Technical Service Bulletin: TSB210055	Released Date: 29-Apr-2021
New Fuel Rail, High Pressure Injector Supply Lines, Fuel Supply Line, and Fuel Supply Line Braces

New Fuel Rail, High Pressure Injector Supply Lines, Fuel Supply Line, and Fuel Supply Line Braces

Figure 1, New Fuel Rail.

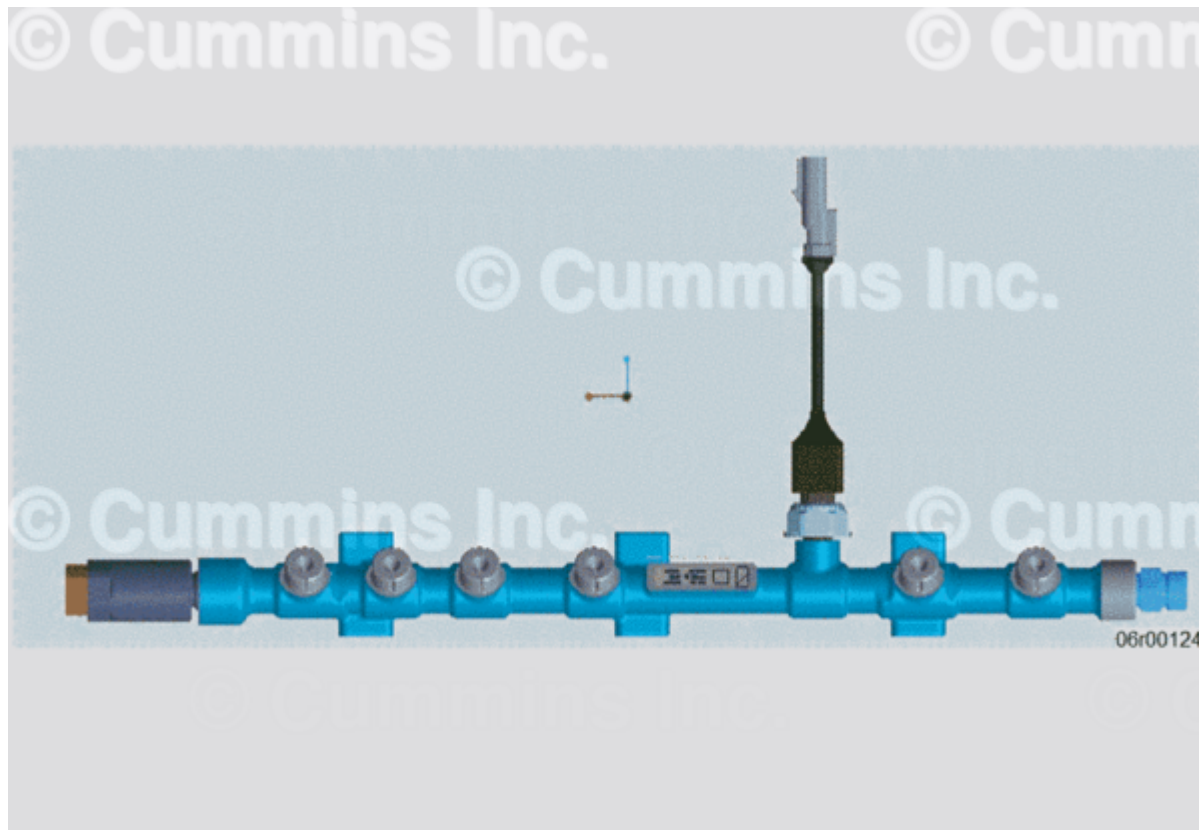
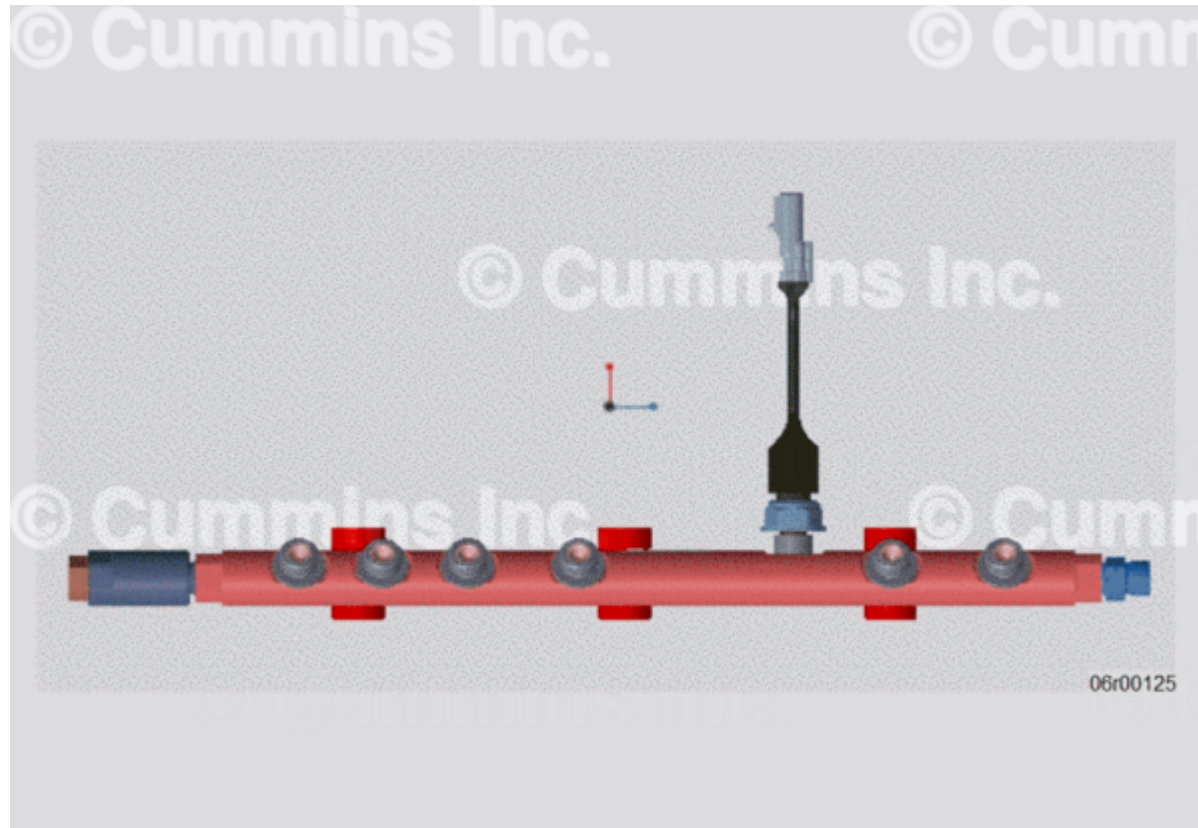
A new fuel rail is available along with new high-pressure injector supply lines, fuel supply line, and fuel supply line braces. The new fuel rail is **not** compatible with the existing high-pressure injector supply lines.

1. New fuel rail can be identified by the shape.

- New fuel rail is **only** compatible with new high-pressure injector supply lines, and fuel supply line and fuel supply line braces.
- Existing fuel rail is compatible with either existing or new high-pressure injector supply lines, and fuel supply line and fuel supply line braces.

Figure 3, New High-Pressure Injector Supply Line, Part Number 5481953 (Injector 1).

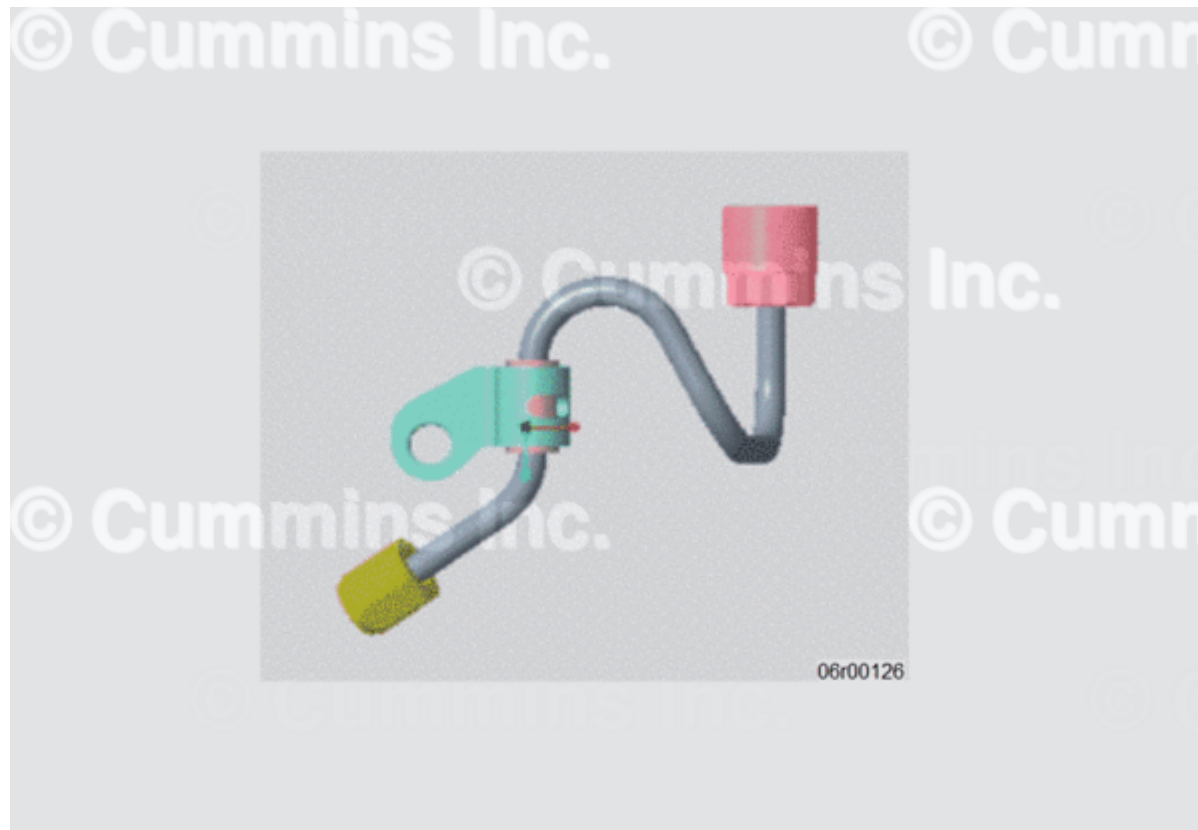
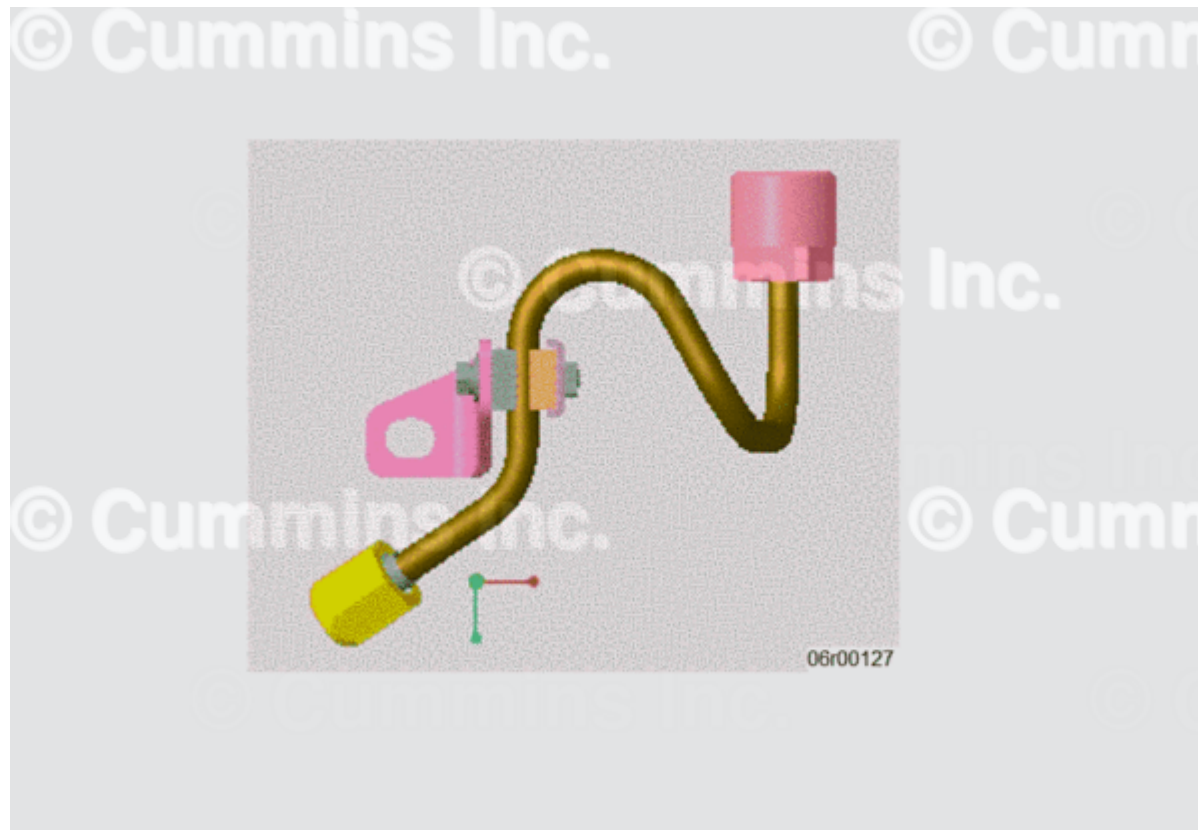
2. High pressure injector supply lines can be identified by the shape.

Figure 15, New Fuel Supply Line, Part Number 5525526 (Pump to Rail).

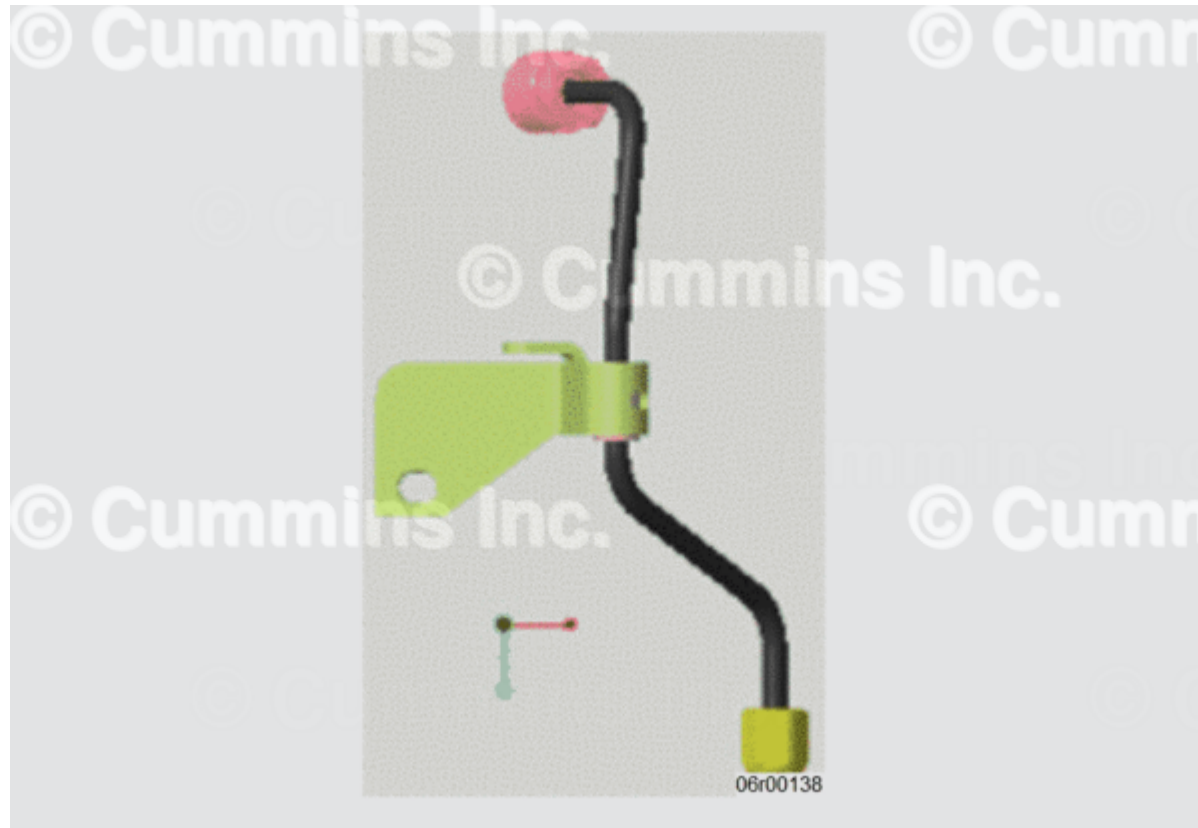
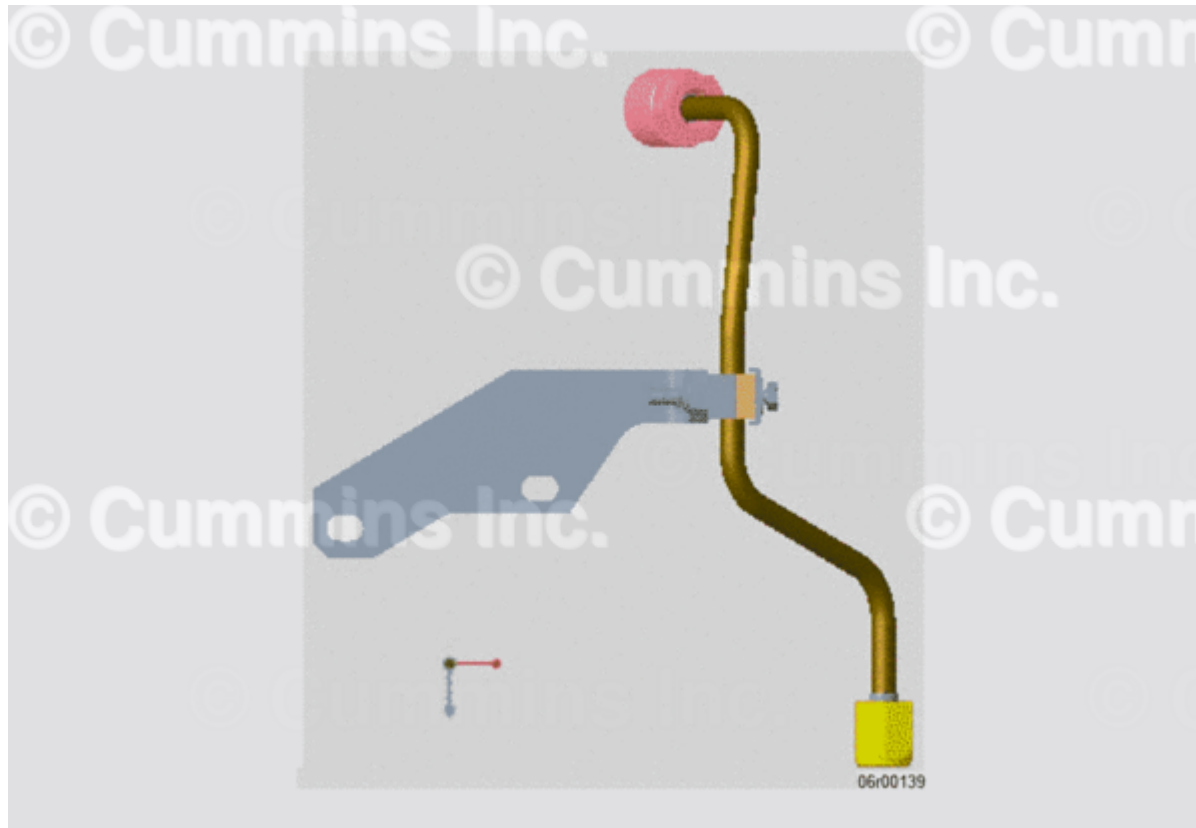
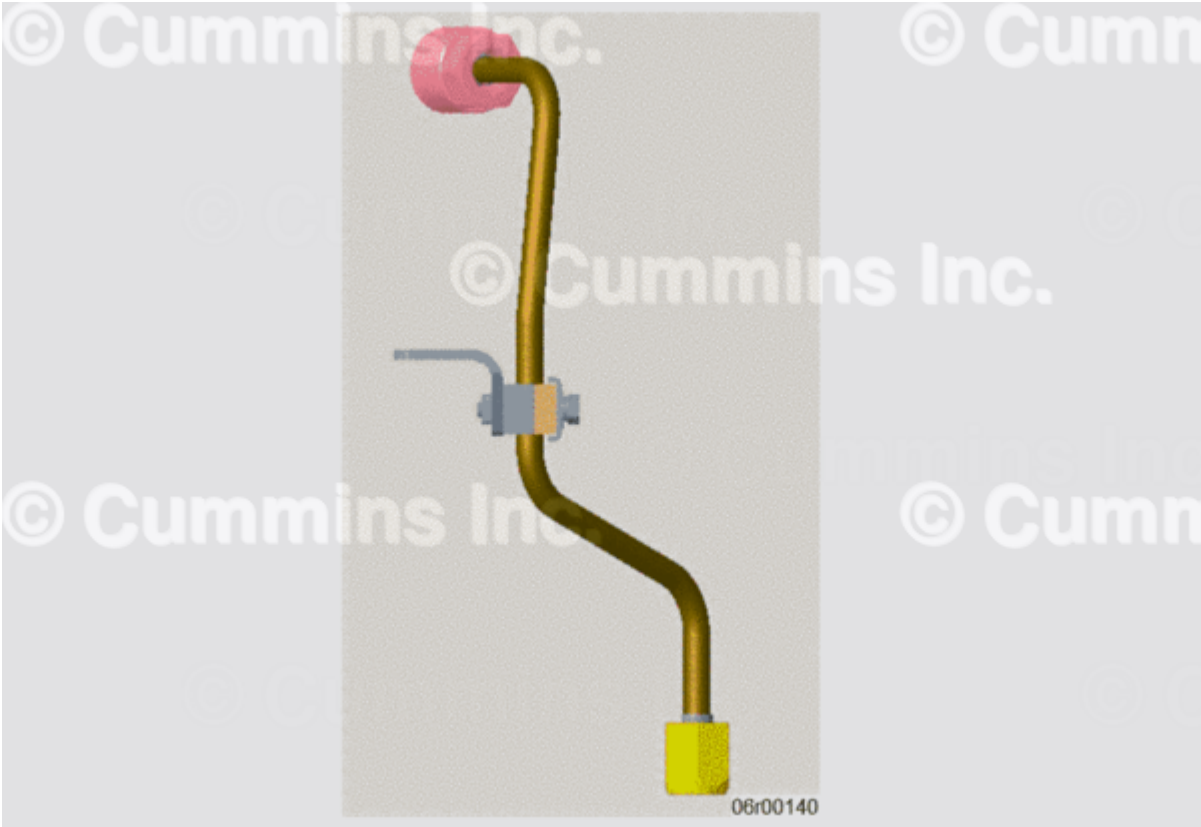
- If existing fuel rail has malfunctioned, replace with the new fuel rail.
 - New high-pressure injector supply lines **must** be used with the new fuel rail.
 - New fuel supply line and new fuel supply line braces **must** be used with the new fuel rail.
- If the existing high-pressure injector supply line has malfunctioned, replace with new high-pressure injector supply line.
 - Do **not** replace the fuel rail.
- If the existing fuel supply line has malfunctioned, replace with new fuel supply line.
 - Do **not** replace the fuel rail.
